Bid Bulletin #2

PROJECT: York General Hospital OR Renovation

DATE: January 14, 2016

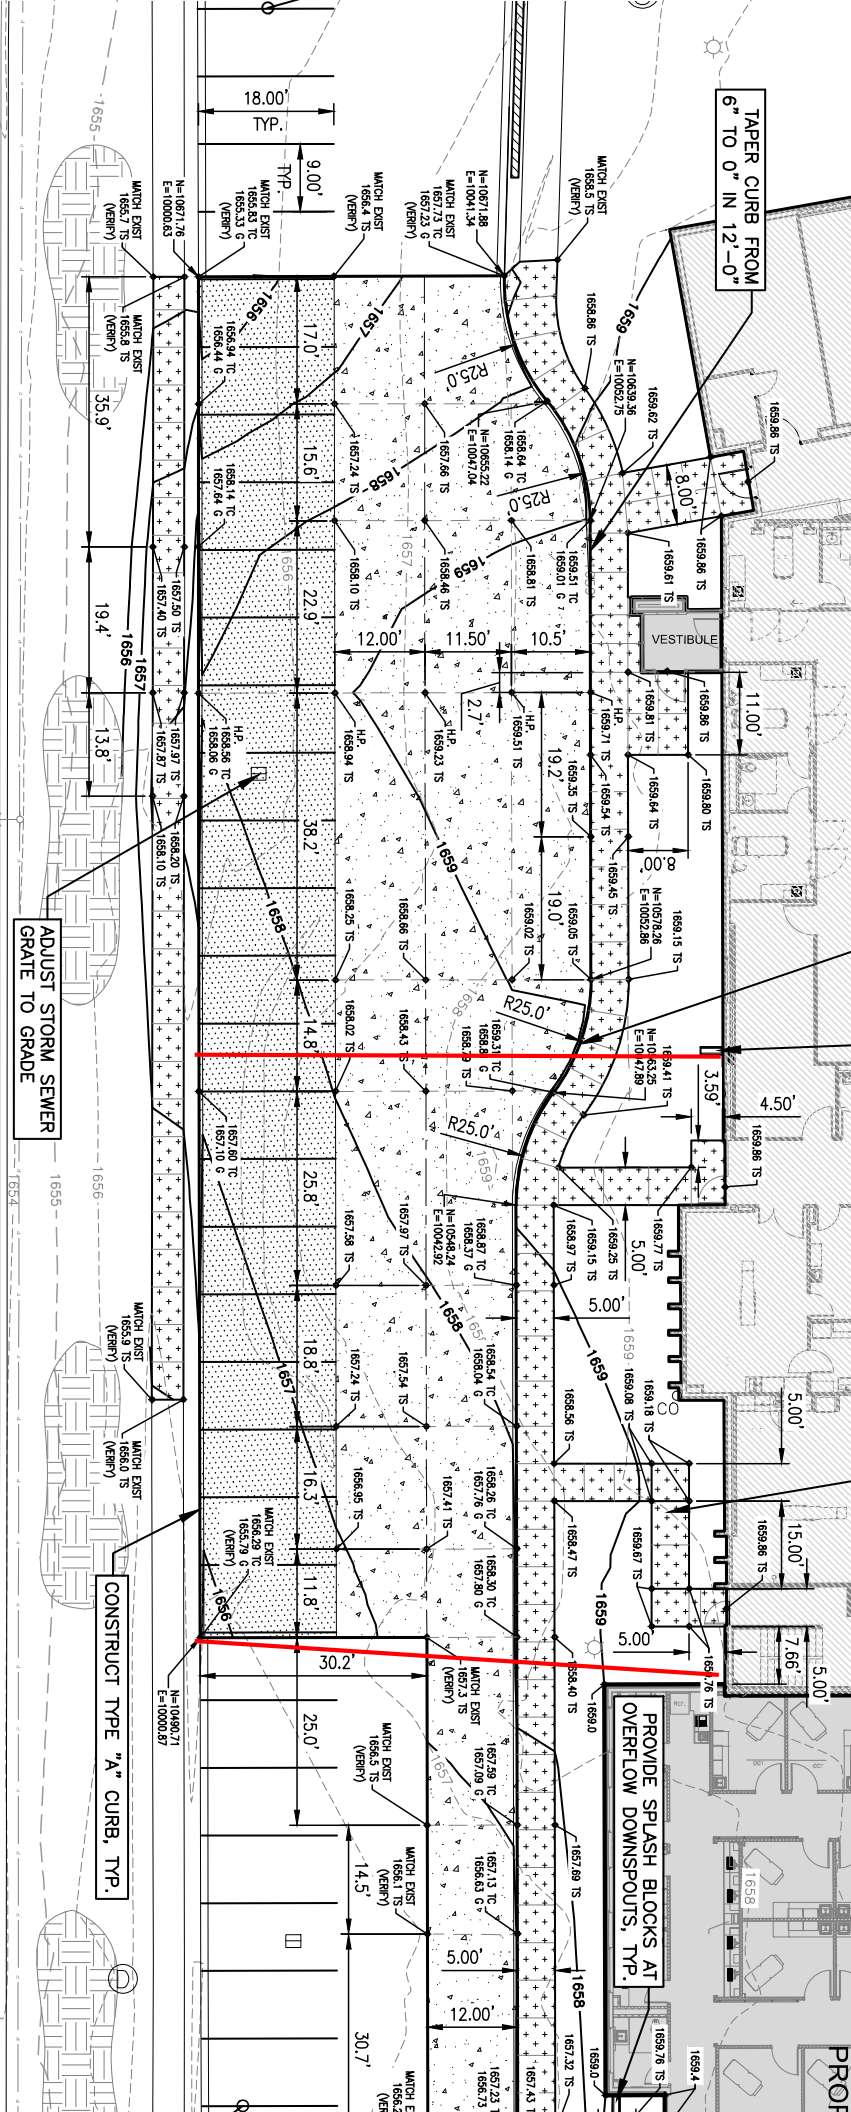
- Item 2-1 Attached is the phasing drawing- Drywall contractors to pay close attention to this layout and the requirements to provide construction separation and also rated separations. Existing walls will need to be updated. Removal of construction separation walls (were as the wall will not be reused) will be the responsibility of this contractor to remove.

- Item 2-10 A updated Bid Form attached.
- Item 2-11 A updated phasing plan which includes south area of corridor 1100
- Item 2-12 Emailed Bids will be accepted. Bids to be emailed way prior to 1:30 bid date so that bids can be printed prior to 1:30. Bids can be emailed to Bob Ailor at bob.ailor@yorkgeneral.org.

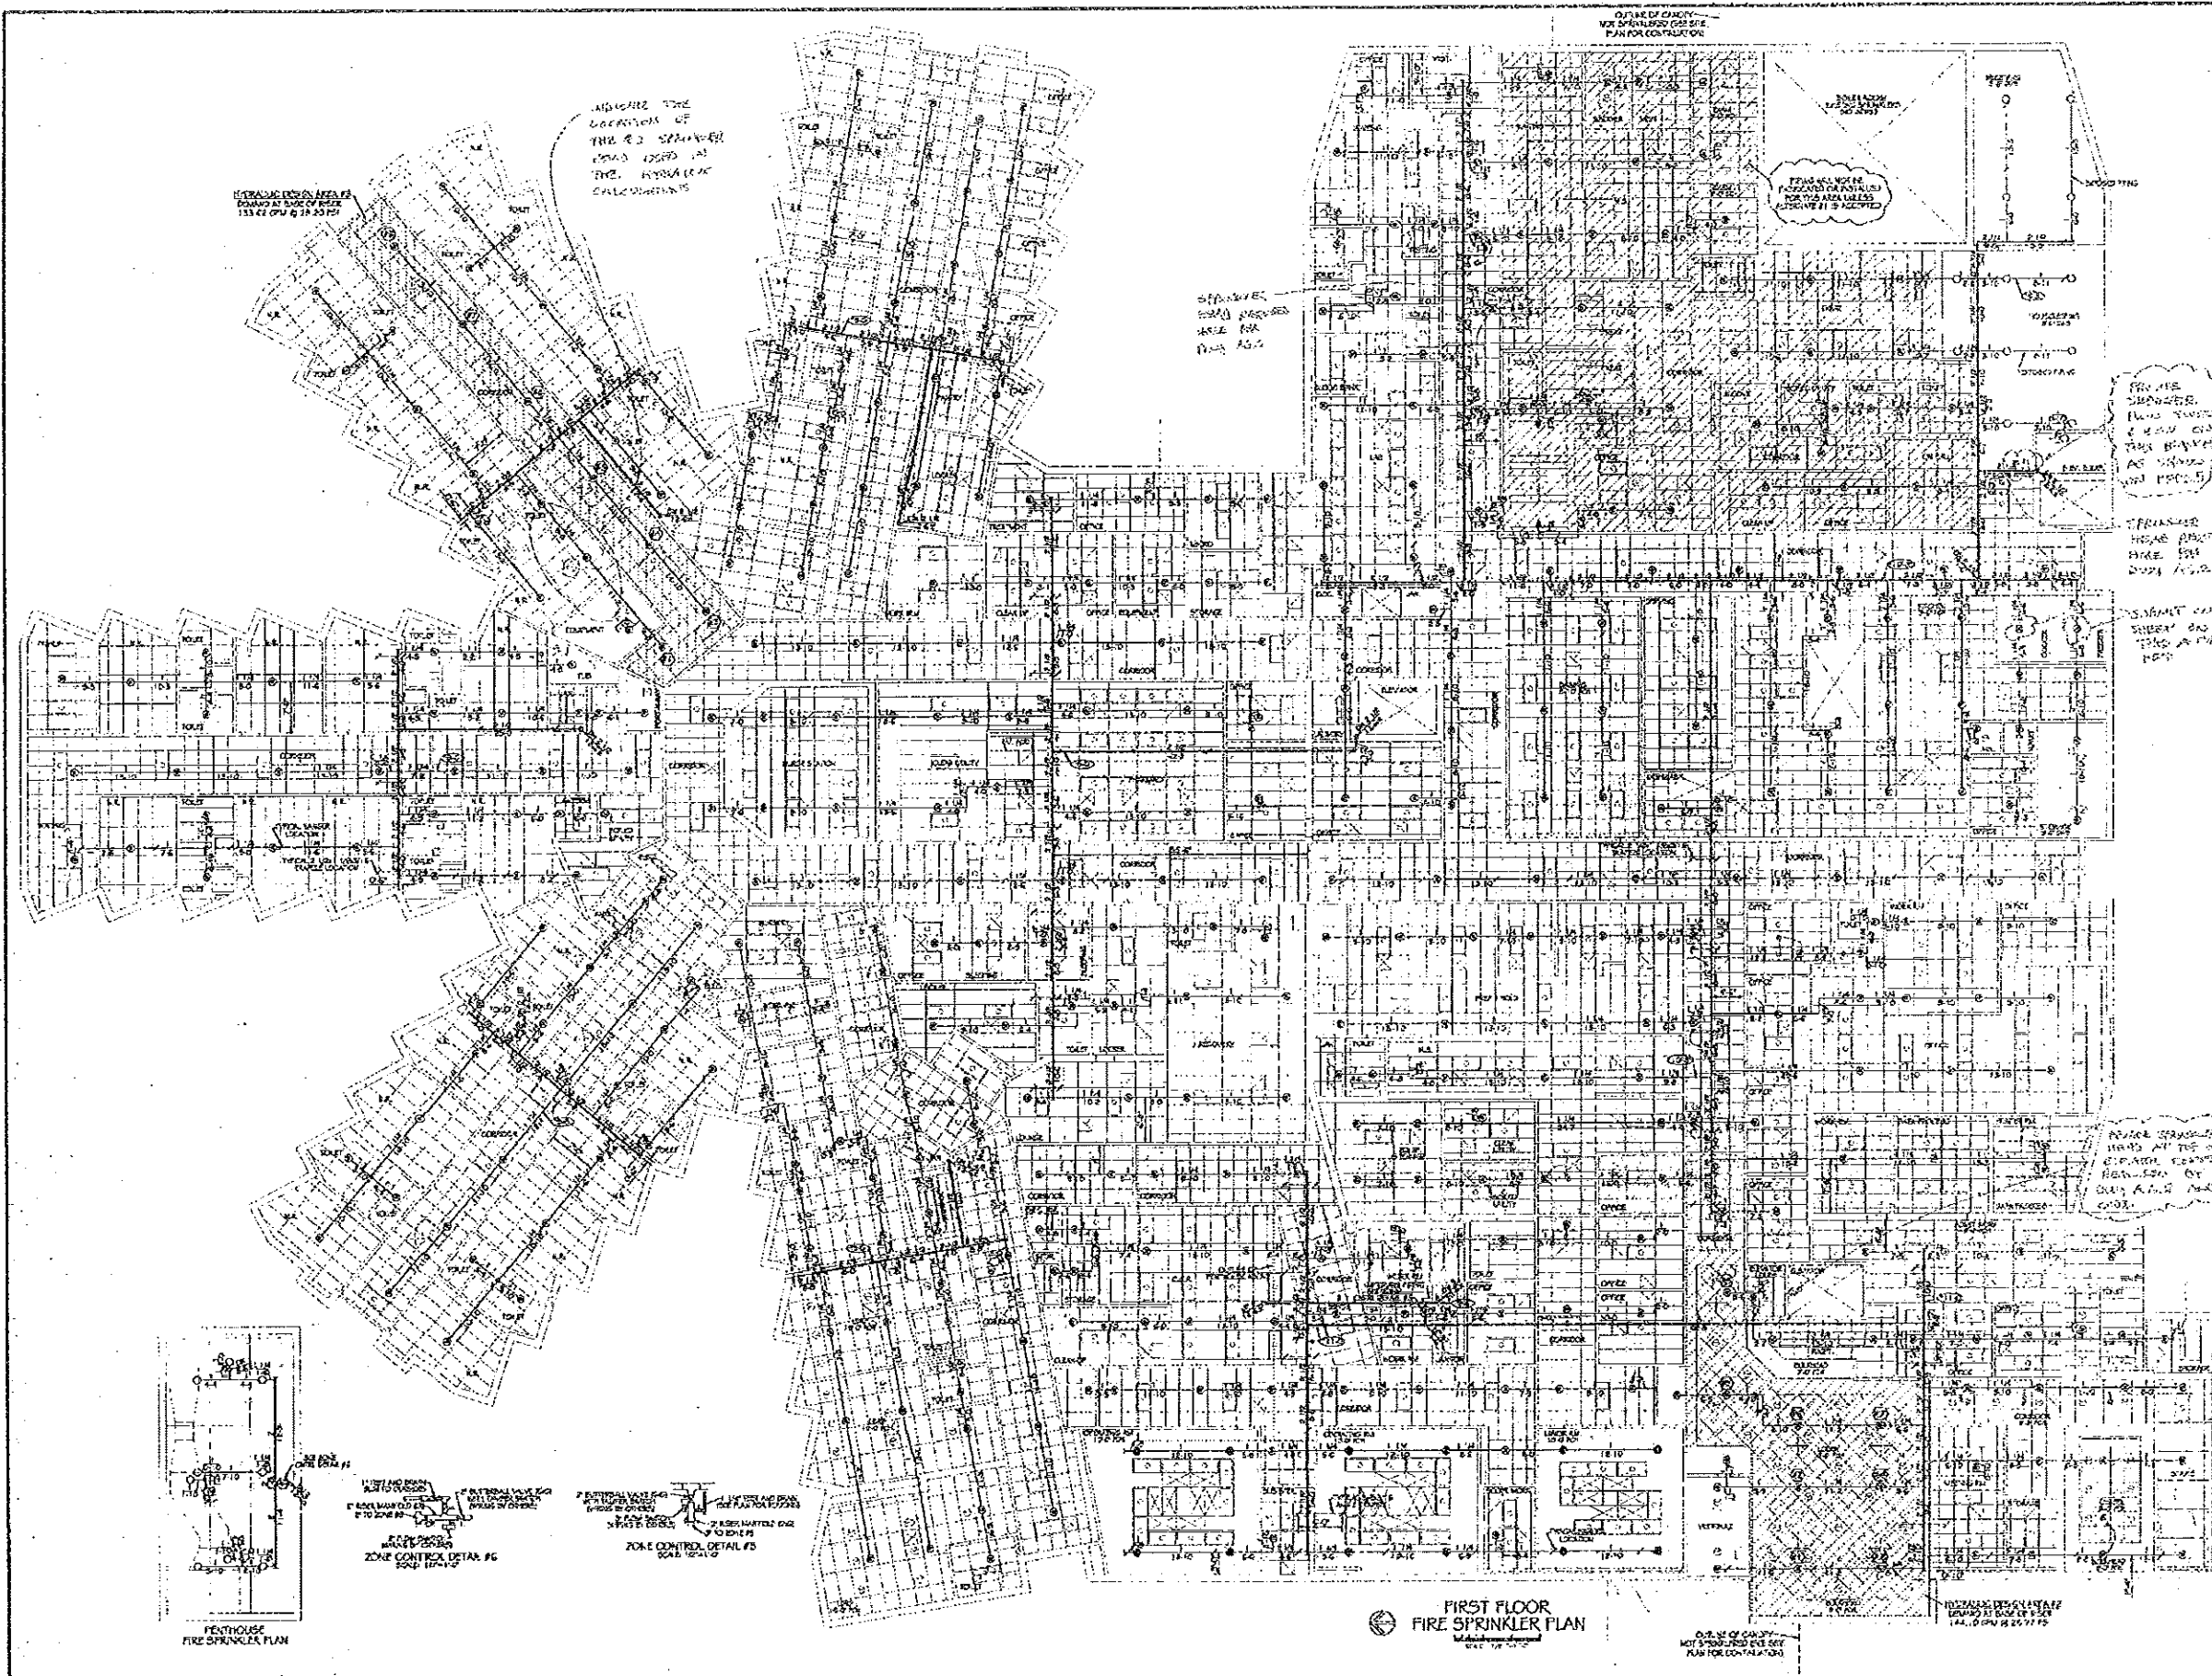
- Item 2-6 Paving drawing attached to show what work is remaining
- Item 2-7 Final duct cleaning will not be required as long as duct work is installing in the manner per Advanced SMACNA. Duct work will be checked randomly. If duct work is not protected nor cleaned during installation, contractor will be required to have final clean done prior to commissioning.

FIRST FLOOR FIRE SPRINKLER PLAN

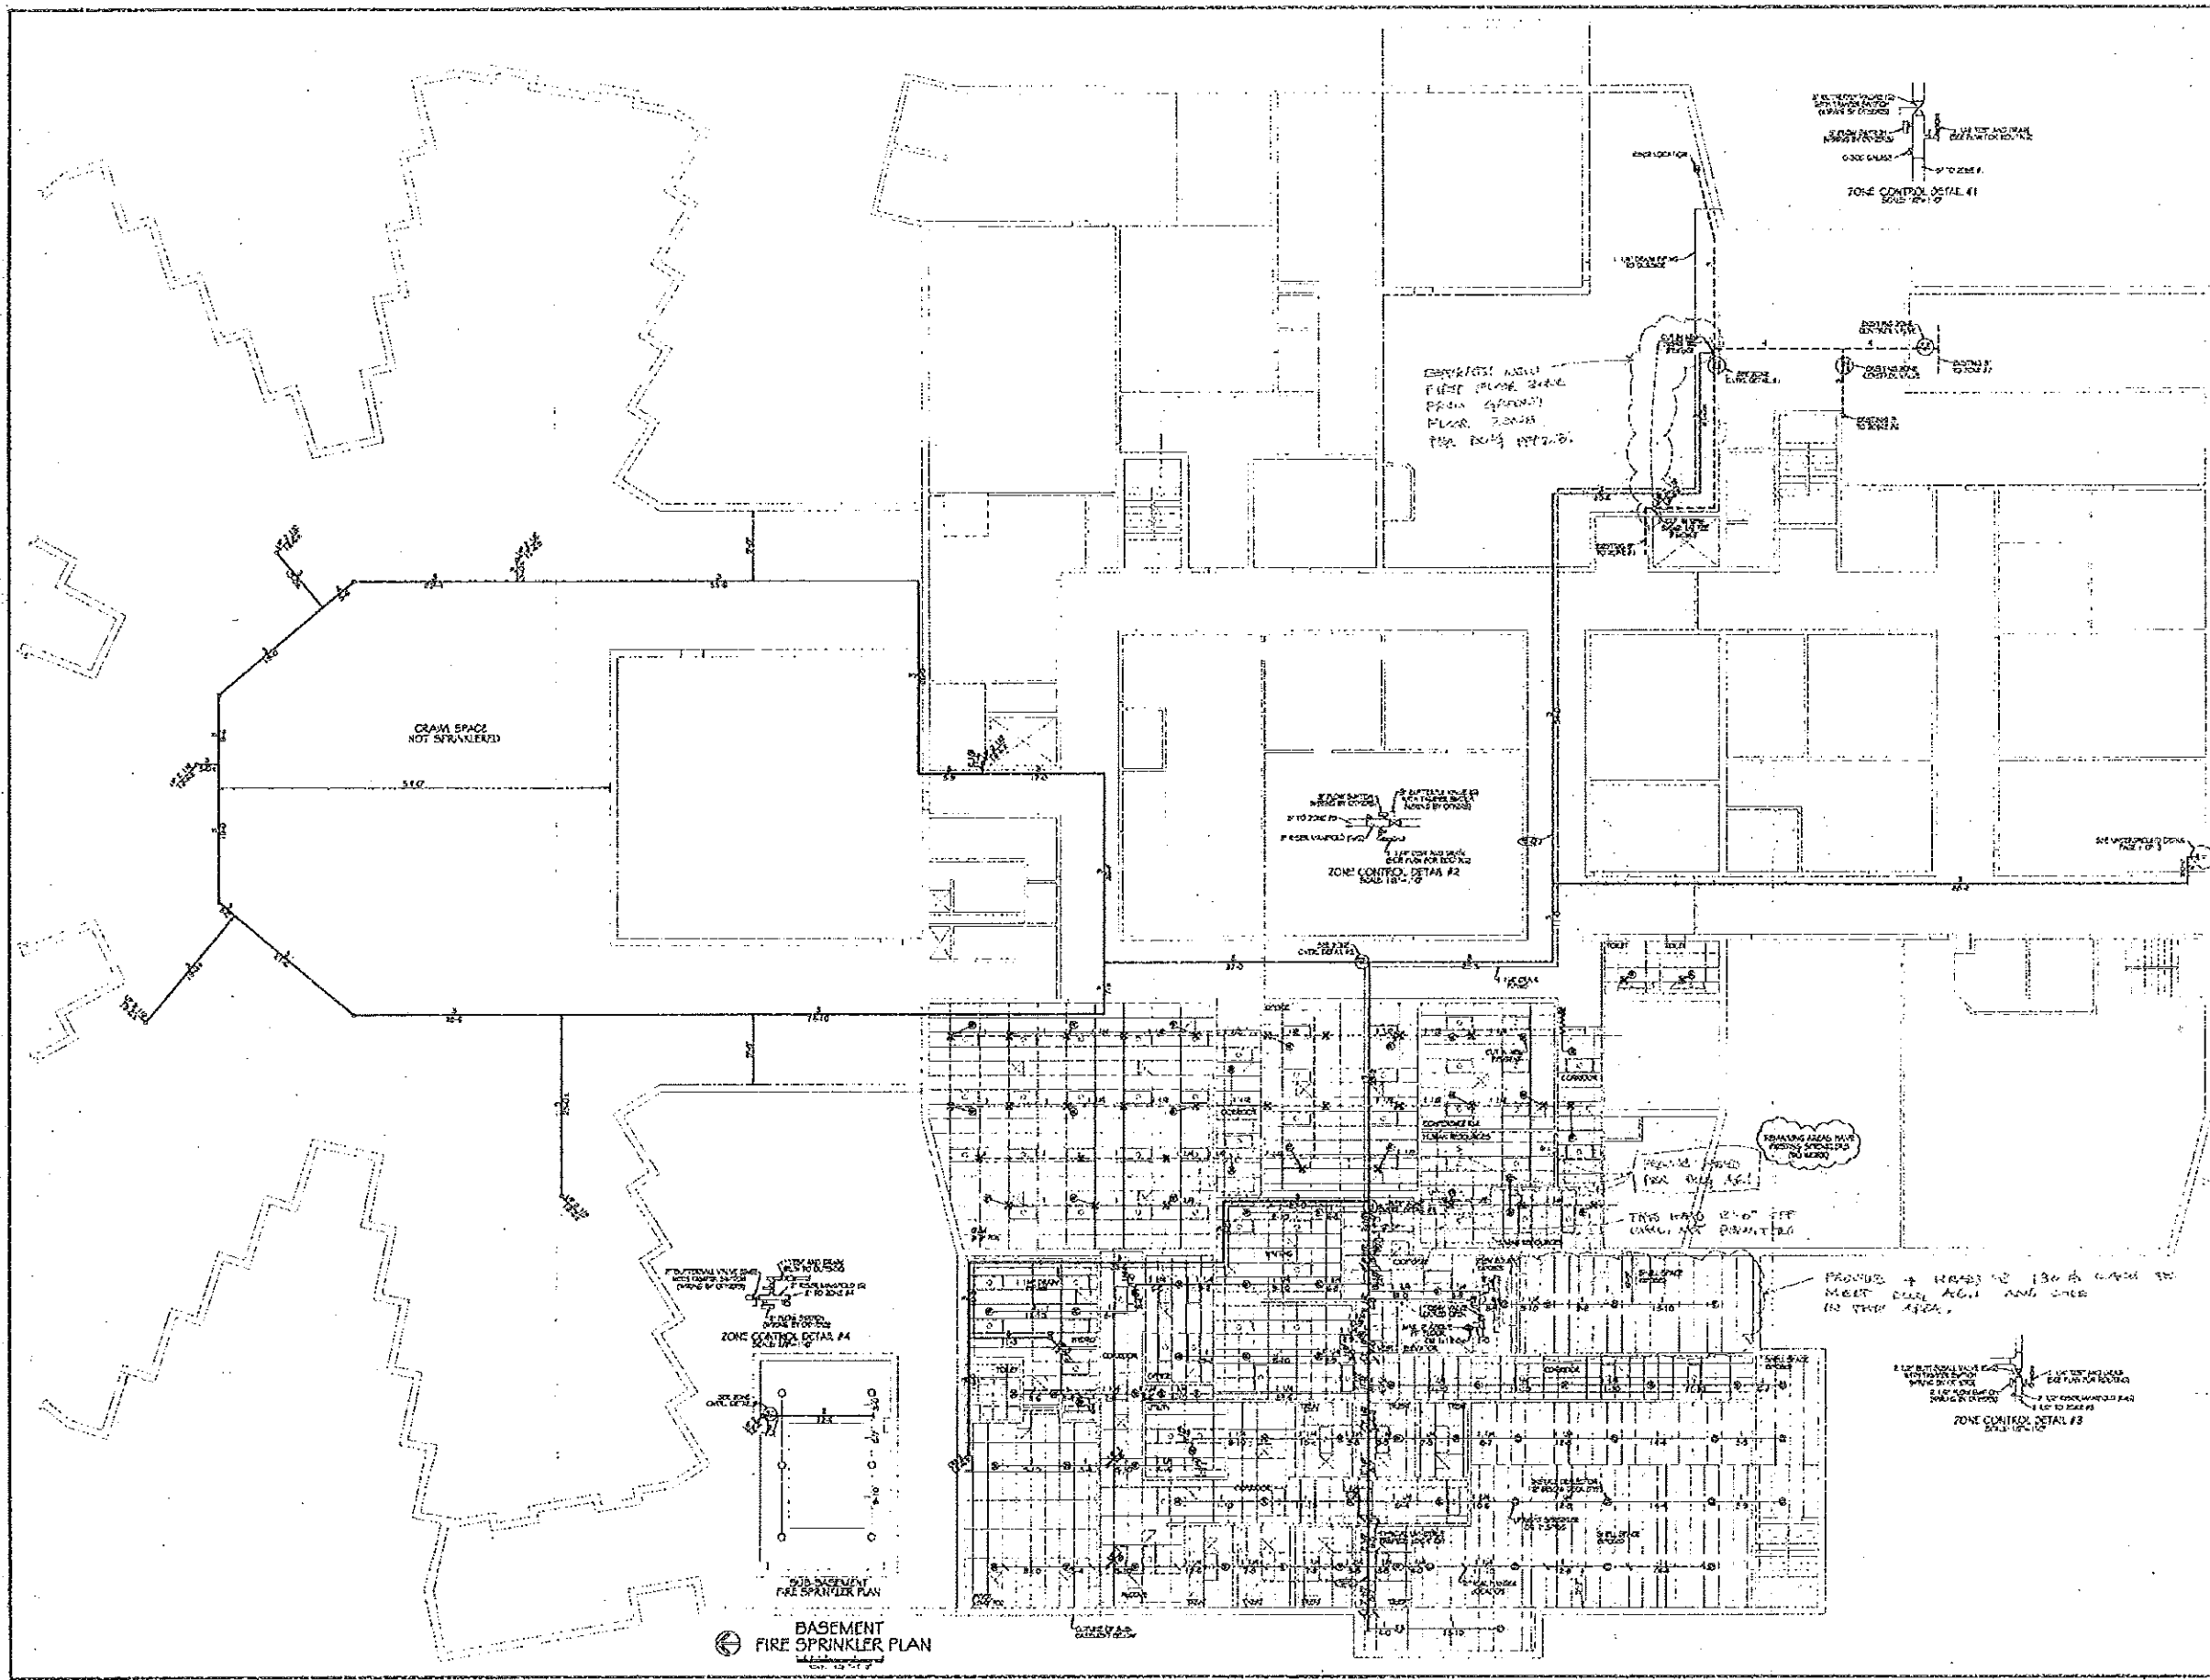
- Item 2-8 Existing sprinkler drawings available at job house and (11x17-Attached) Figure (4) Additional valves will be required to provide coverage of new and existing areas.
